3/8/2020: There appears to be only one windshield upper defog fan, mounted along windshield centerline. Only one fan switch exists (labeled LEFT FAN) but this may be a retrofit as the right fan hole has a blanking plate. ?? Front and back of switch are shown.

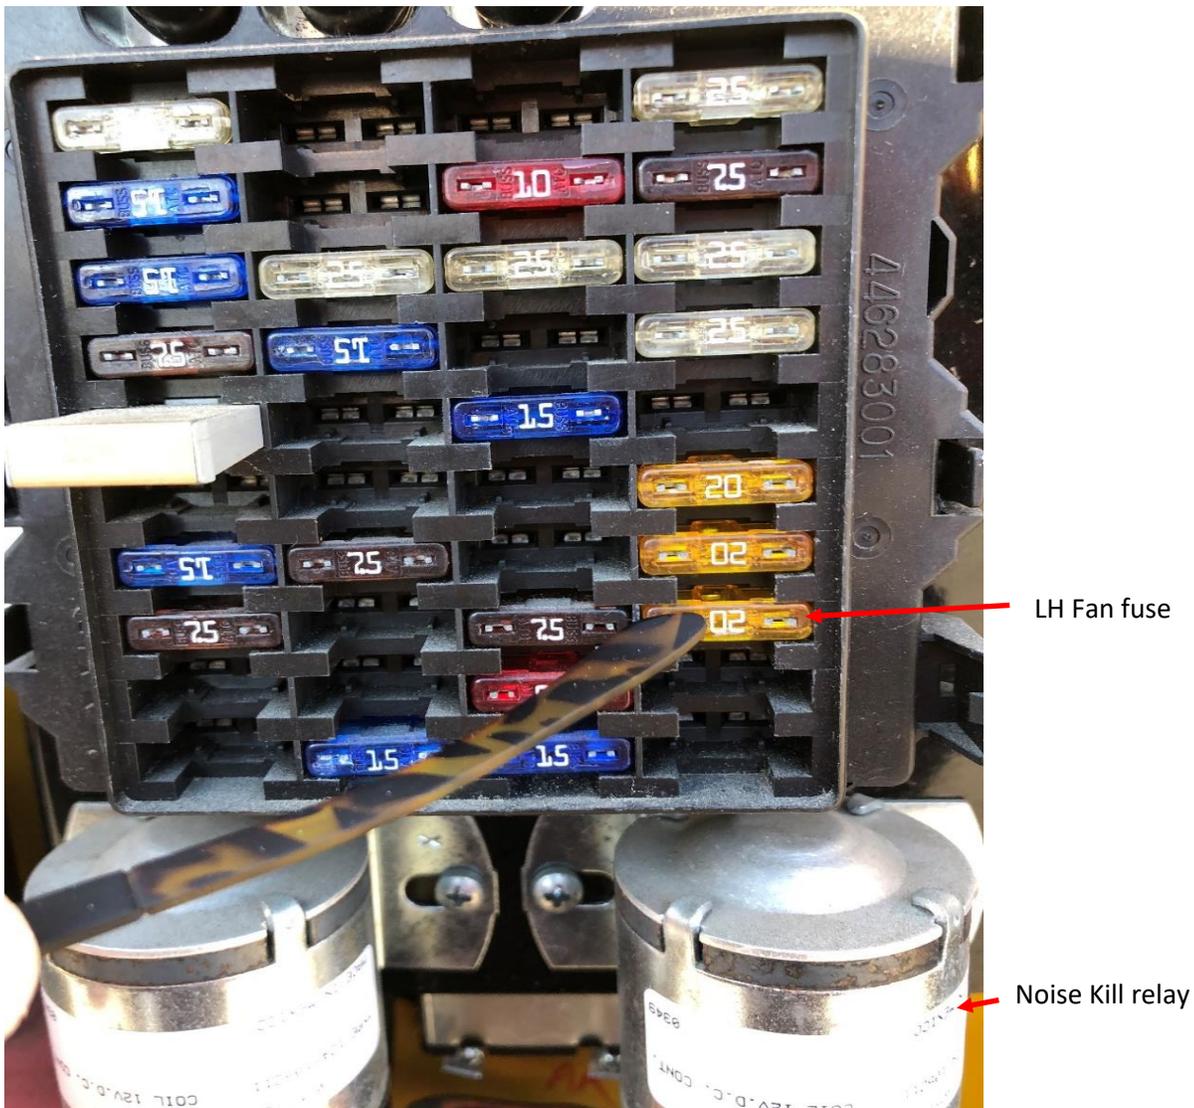
This switch showed erratic response.

Sometimes the fan would run with switch in LO or HI position, but not both in the same OFF/LO/HI/LO/OFF cycling of the switch.

The fan did not respond to the switch most of the time.

12VDC was consistently available at the back side of the connector block.

Switch date code seems to indicate 27th week of 2003. They do wear out.

I recommend replacing the switch. I'll check price & availability.

3/28/2020: UHL's crossreferenced a direct replacement switch: International # 6131248C1. Replaced existing failed switch. Removable terminal block was not altered. Mounting plate and switch were returned to operating position on dash. Fan responded properly and reliably through six OFF/LO/HI/LO/OFF cyclings of the switch.

New switch seated securely into removable terminal block.

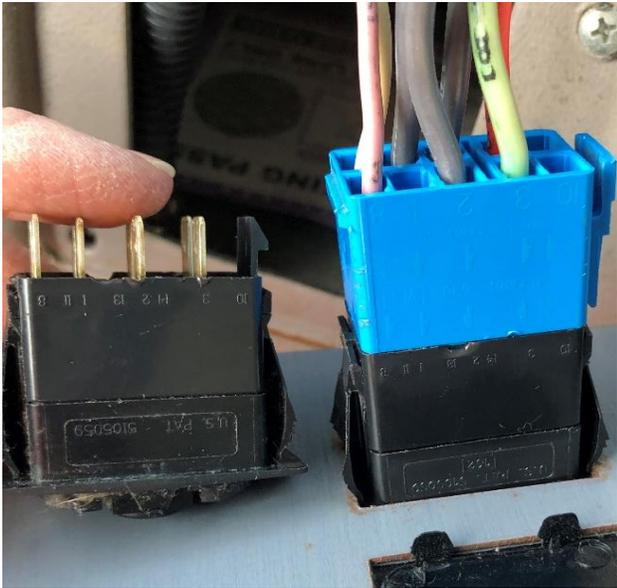
Fuse #38 listed as LH DEFOG FAN, 7.5A. Actual device is 20A.  
 According to fuse block schedule there should be separate 7.5A fuses for two defog fans.  
 12VDC power constantly available at fuse #38 with NOISE KILL switch ON.
